Access Compliance Report

Public Rights-of-Way

Intersection ID: 4705	Main Street: HARRIS_HOUSTON_RD	Cross Street: KEMPSFORD_DR	Location:	N
ADA ID: B5C2C7C21590	Ramp Type: Perp	Initial Pass/Fail: Fail	Overall Compliance: No	Severity Score: 13.75

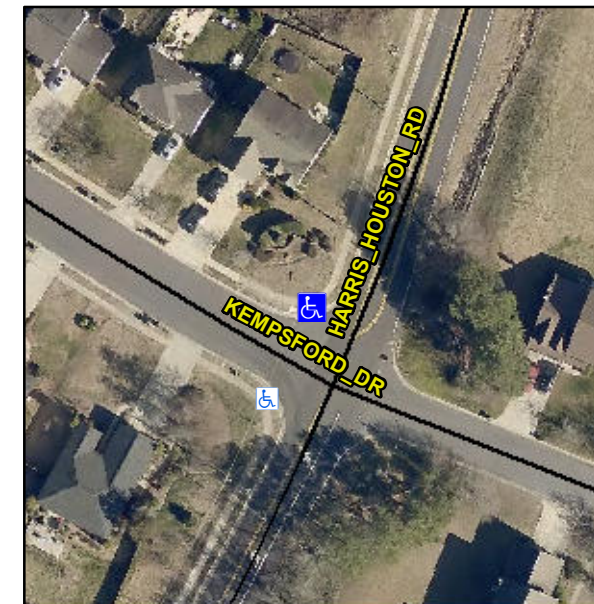
R304.2.2, R304.5.3

Compliance	Description	Data	Compliance	Description	Data
N/A	Ramp Length (in)	47.0	No	Ramp Slope (%)	9.0
Yes	Ramp Width (in)	50.0	No	Ramp XSlope (%)	4.8
N/A	Flare Type LT	N/A	N/A	Flare Type RT	N/A
N/A	Flare Slope LT (%)	N/A	N/A	Flare Slope RT (%)	N/A
N/A	Flare Traversable LT?	N/A	N/A	Flare Traversable RT?	N/A
N/A	Landing Length (in)	N/A	N/A	DWS Provided?	N/A
N/A	Landing Width (in)	N/A	N/A	DWS Contrast?	N/A
N/A	Landing Slope (%)	N/A	N/A	DWS Length (in)	N/A
N/A	Landing X Slope (%)	N/A	N/A	DWS Full Width?	N/A
N/A	Landing Curb? (Y/N)	N/A	N/A	DWS Offset (in)	N/A
N/A	Shared Landing?	N/A			
N/A	Gutter Ponding?	N/A	N/A	Gutter Slope (%)	N/A
N/A	Gutter Lip Ht (in)	N/A	N/A	Gutter X Slope (%)	N/A
N/A	Painted X Walk1?	No	N/A	Painted X Walk2?	N/A
	X Walk 1 Direction	To SW		X Walk 2 Direction	N/A
N/A	X Walk 1 Width (in)	N/A	N/A	X Walk 2 Width (in)	N/A
	X Walk 1 Slope (%)	6.7		X Walk 2 Slope (%)	N/A
	X Walk 1 X Slope (%)	3.9		X Walk 2 X Slope (%)	N/A

Remove & Replace Entire Ramp.
